Nature of Work: 24 SQ T/O REROOF WITH PIONEER LTWT TILE

MRS. Mei Lee at
7305 Flowerwood
95831
TILE ROOF WORKSHEET

ROOF PLAN - YEE

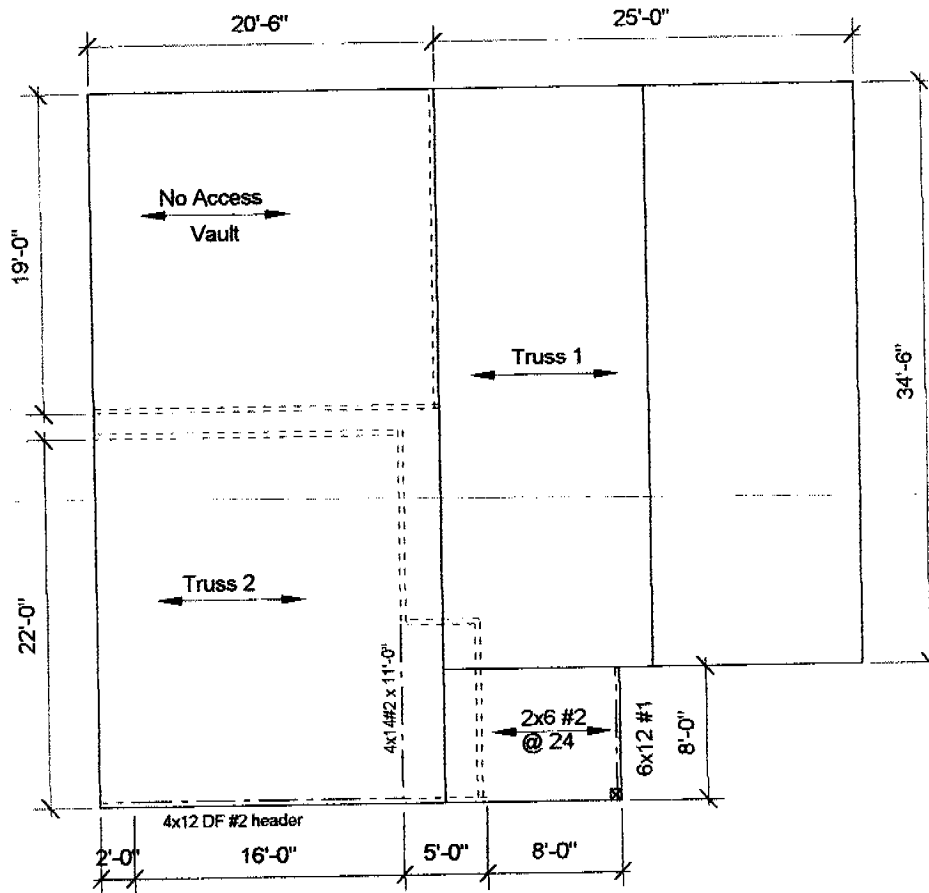
See Truss 1 on sheet 5. Verify it has support as shown
1/4" shear has to verify rafter framing is adequate after removal of material + send back in for plan deck
